INFORMAL GROUP ON GASEOUS FUEL VEHICLES
Within the UN GRPE (WP29)
PROPOSED AMENDMENT GFV-04-04

Regulation name and reference number: Regulation 115

Document in support to the GFV-04-02, providing the rationale on the Chassis dynamometer setting proposals for the Type 1 test.

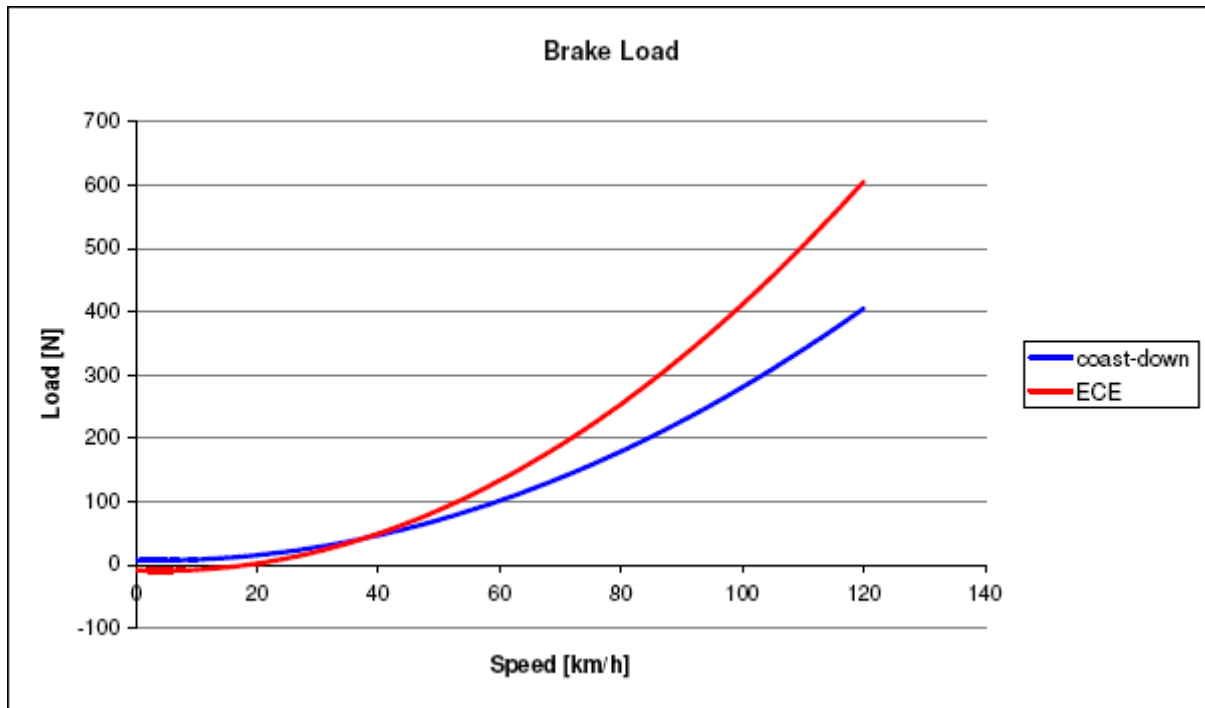
The speed vs. dyno load (in N) for the vehicle converted with the LPG system is shown in the next graph.

It is clear that at higher speeds, the table values lead to higher chassis dyno load settings.
